Memo

To	Neil Dixon	Company	Mardie Minerals Pty Ltd
From	Bruce Harvey & Duncan Storey	Job No.	293C
Date	4/11/2020	Doc No.	009b
Subject	Mardie Project – Desktop Groundwater Risk Assessment

Figure 7
**Mardie Project
 Potential Coastal
 Groundwater
 Receptors**

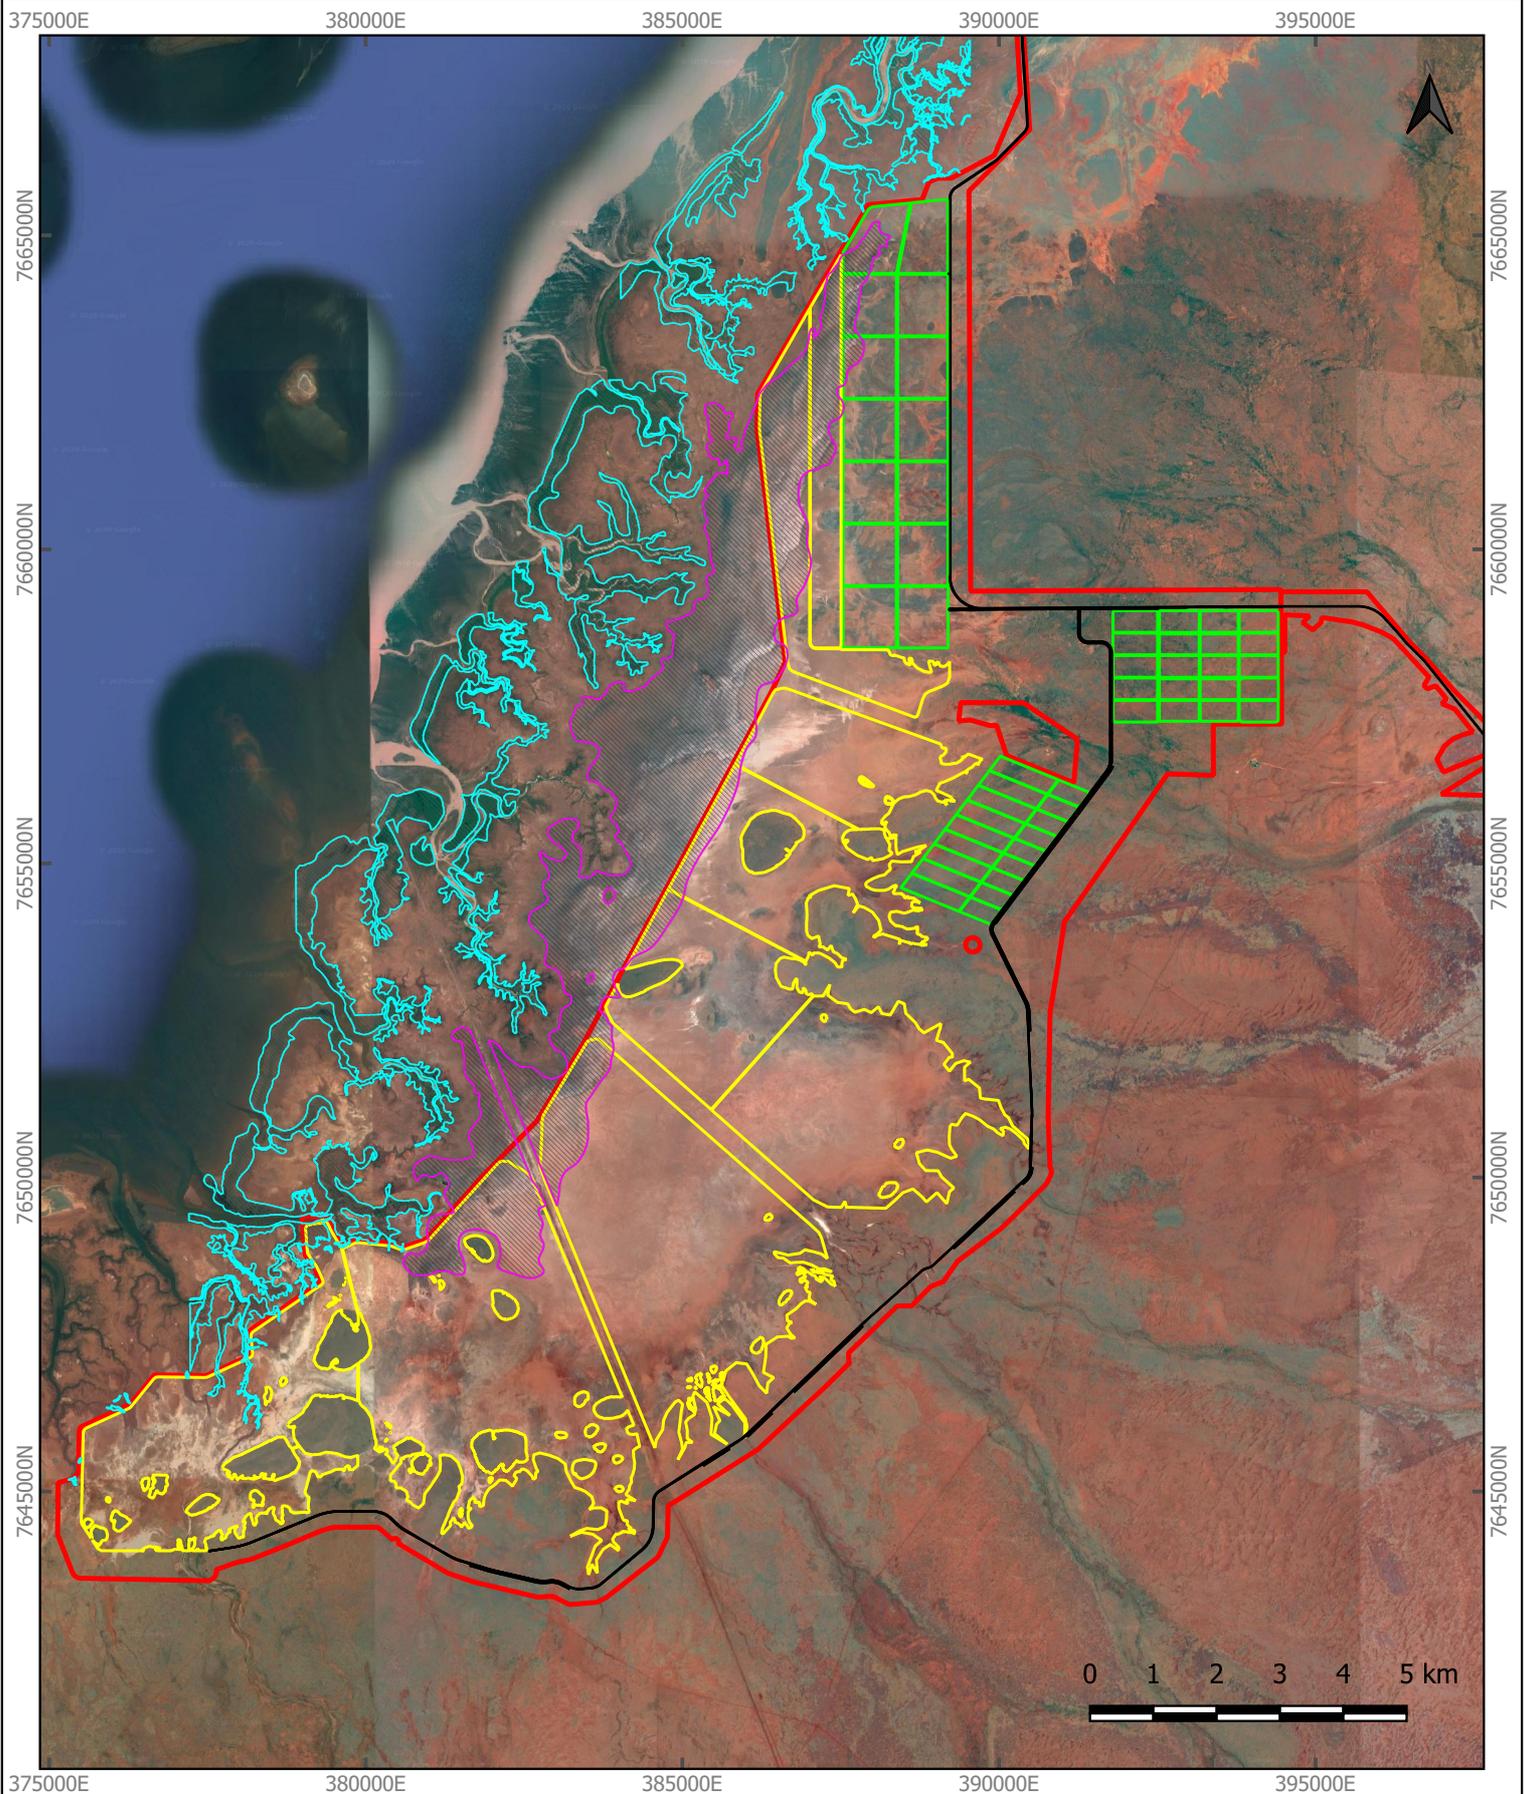
Figure 7 displays the mapped extent of mangrove species and Algal mats at Mardie (Phoenix Environmental Services 2020). Proposed ponds are positioned close to, or impinge upon, mangrove habitat at Evaporation Ponds 1 and 2 in the south, and near the primary crystalliser ponds in the north. Evaporation Ponds 3 to 8 are generally greater than 1km from mangrove areas. Ponds also are proposed to be constructed across large areas of land mapped as algal mats, with remaining areas of algal mat coverage existing to the immediate west of Ponds 2 to 8.
